Melrose Park, Lot AB, 657-661 Victoria Road & 4-6 Wharf Road – Noise Impact to Unit 2101

This report details the acoustic review and assessment of studio unit located on level 2 of the proposed Melrose Park, stage 4 development and the potential for noise impact from the use of the driveway includes trucks.

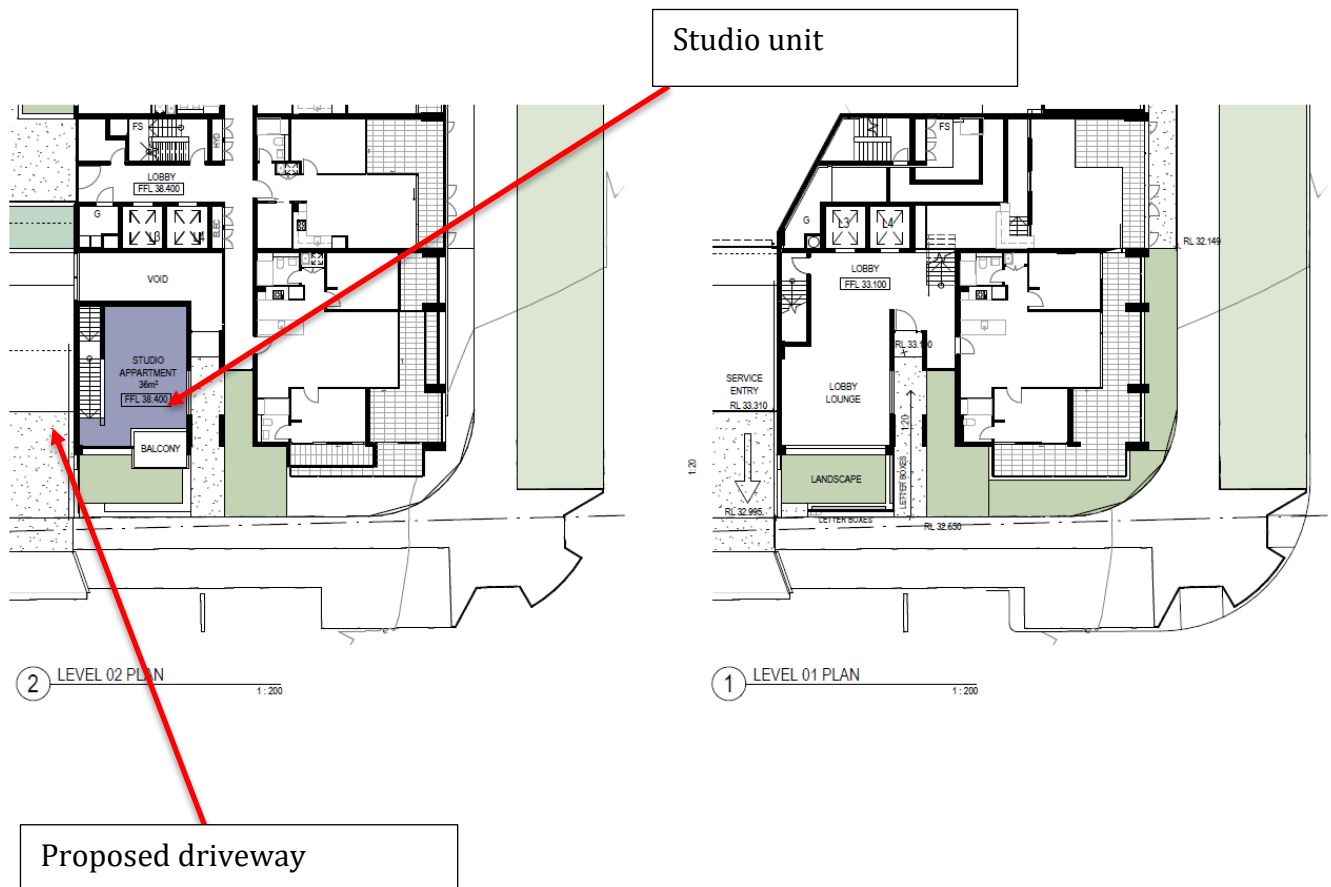
Council Comment: The proposal includes a unit directly adjacent the service vehicle entrance including a window to it. The acoustic report does not consider this unit specifically. This unit should be converted to retail or separated from the driveway by at least 3m and specifically considered by the acoustic consultant.

4H Acoustic Privacy: “... The proposal includes a unit (#2101) directly adjacent the service vehicle entrance including a window to it. The ADG recommends at least a 3m separation between units and driveways. Council’s Acoustic consultant is of the view that the applicant’s acoustic report does not adequately demonstrate internal noise levels within the unit will be acceptable subject to the treatment proposed. The unit is also one of the units which receives no direct solar access. As such, the unit is considered to have unacceptable amenity on merit. A condition is included recommended that the unit be deleted.

The following acoustic treatments are recommended to ensure the amenity and the dwelling:

1. Install upgraded external glazing to the proposed openings to ensure appropriate treatment to the dwelling.
2. Glazing should include a minimum 12.38mm laminated glazing including a minimum performance of the glass and frames of Rw 36.
3. An openings within the façade of the unit should be acoustically treated such that the acoustic performance and the building constructions are maintained. This could include lined ductwork behind any gills or opening required for ventilation.
